UNITED STATES PATENT AND TRADEMARK OFFICE

APPLICATION NO.	FILING DATE	FIRST NAMED INVENTOR	ATTORNEY DOCKET NO.	CONFIRMATION NO.
10/648,784	08/27/2003	Toru Mori	OKI.570	4482
20987	7590	12/22/2004	EXAMINER	
VOLENTINE FRANCOS, & WHITT PLLC			TRAN, TAN N	
ONE FREEDOM SQUARE			ART UNIT	
11951 FREEDOM DRIVE SUITE 1260			PAPER NUMBER	
RESTON, VA 20190			2826

DETAILED ACTION

Attachment # 1

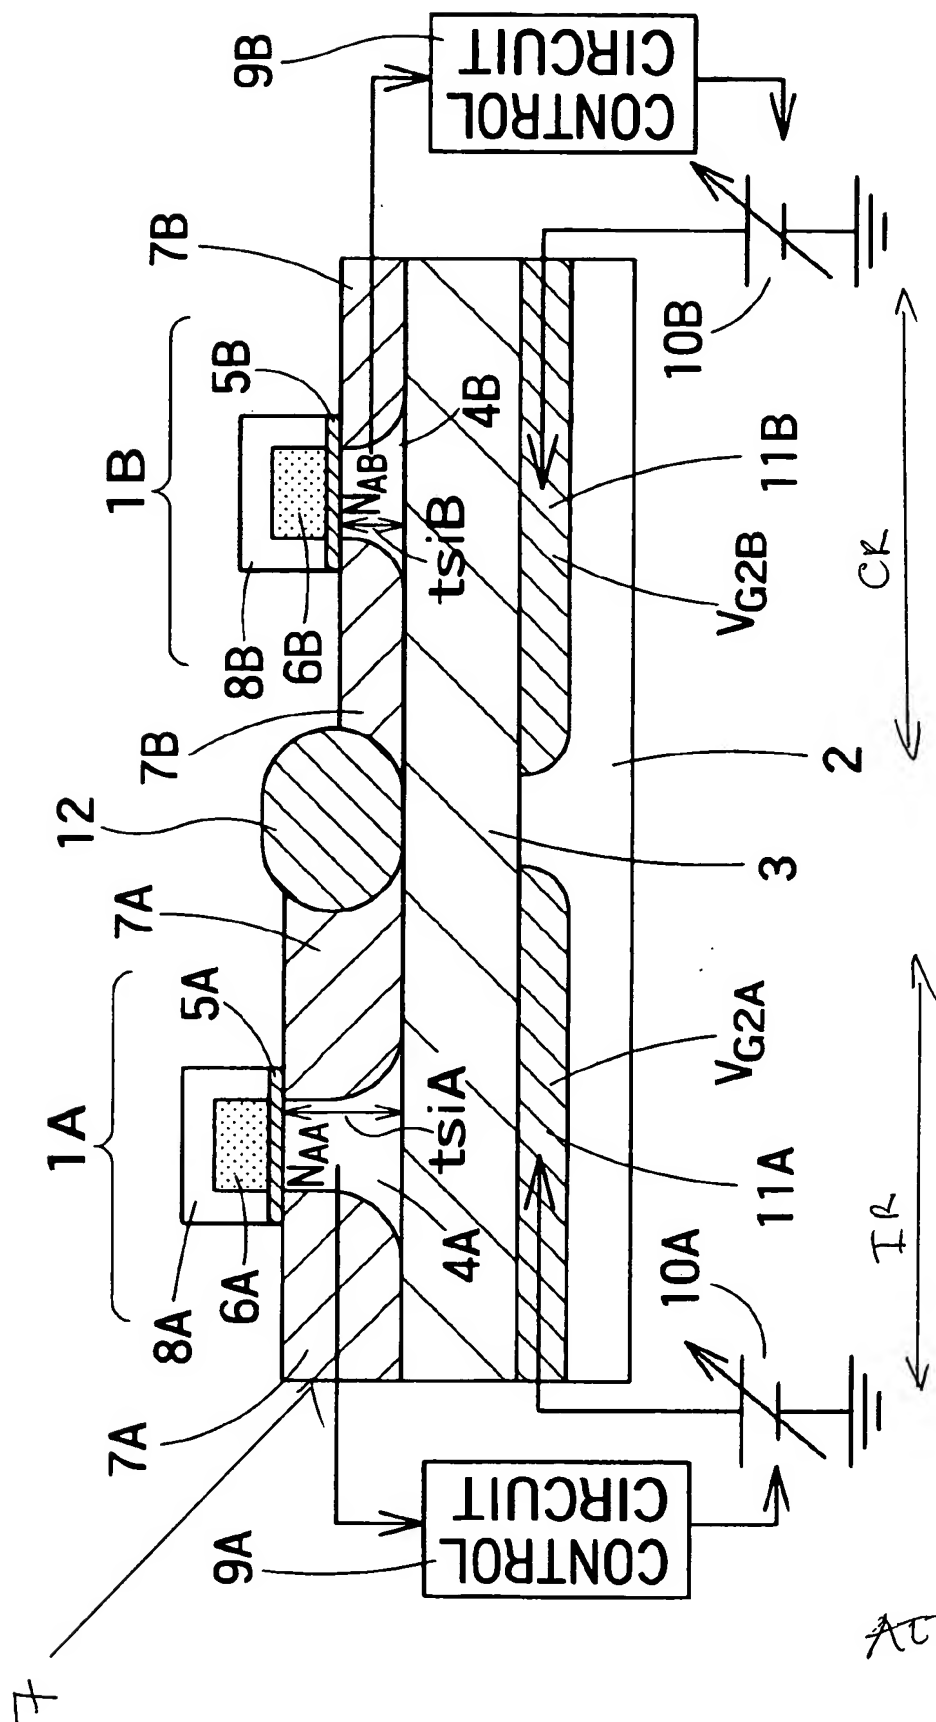
With regard to claim 1, Numata et al. discloses a device comprising an SOI substrate having a SOI layer 7 including a core region (CR) to which a first voltage is applied and an interface region (IR) to which a second voltage is applied; a device separation region 12 for separating the SOI layer 7 into the core region (CR) and the interface region (IR) wherein a thickness of the SOI layer 7 of the core region (CR) is thinner than a thickness of the SOI layer 7 of the interface region (IR), a plurality of first transistors 1B formed in the core region (CR) and in which the SOI layer 7 of the above core region (CR) is a fully depleted Si channel; and a plurality of second transistors 1A formed in the interface region (IR) and in which the SOI layer 7 of the above interface region is a fully depleted Si channel. (Note attachment #1, lines 41,42, column 8; lines 30-33, column 21, fig. 35 of Numata et al.). It is inherent that Numata et al. discloses a second driving voltage of an interface region is higher than the first driving voltage of a core region because the structure of Numata et al. is formed the same as that of applicant, thus the structure of Numata et al. has the same functions as the structure of applicant.

With regard to claim 3, Numata et al. discloses a thickness of the SOI layer 7 of the above core region (CR) is 20 nm. (Note attachment #1, lines 40,41, column 21, fig. 35 of Numata et al.).
